Florida Department of Environmental Regulation

October 6, 1992

Re: Request to Amend Construction Permit No. AC 27-186923
Cement Kiln #1

#1 Cement Kiln Amendment Request: AC 27-186923

FM&M Kiln No. 1 Process Flow Diagram

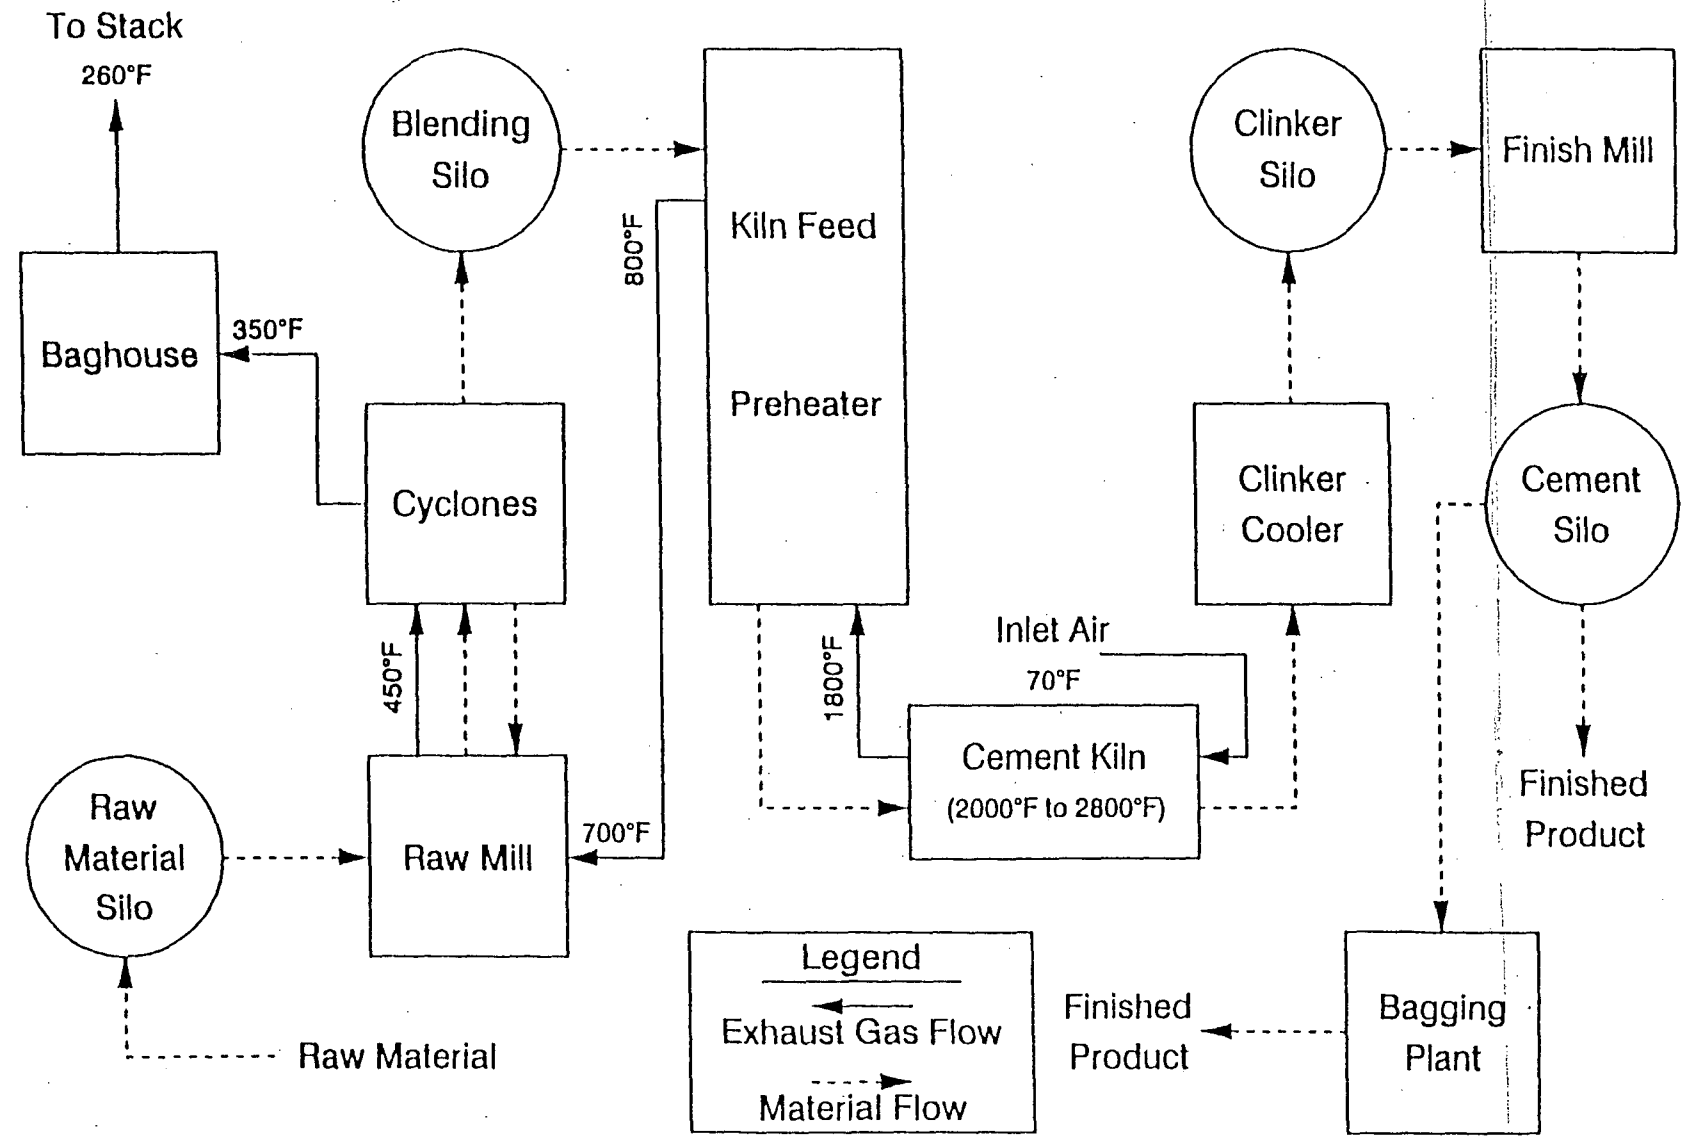
- o The #1 cement kiln is connected in series with the #1 clinker cooler, which is connected in series with the #1 clinker storage silos. Since it appears that the #1 CPLHS is not connected to the #2 CPLHS, except for the raw material feed into the raw mills, then the #1 clinker cooler and other #1 auxiliary sources do not receive clinker product without their #1 cement kiln operating.

- o It is apparent that there is an incompatibility between the the permitted operation capacities of the #1 cement kiln and its associated clinker storage silos (i.e., 79.9 vs. 84 tons/hr). As stated before, the operation of the #1 clinker cooler and the associated #1 clinker storage silos depend on the product output of the #1 cement kiln.

Since the product yield of the #1 cement kiln is the factor used in estimating the potential pollutant emissions for it and associated sources operating in series with it, the Department cannot justify deleting the federally enforceable condition establishing the allowable maximum clinker product of the #1 cement kiln. However, if an increase in the clinker product is desired, then an application for a modification shall be submitted along with the appropriate processing fee to the Department's Bureau of Air Regulation office.
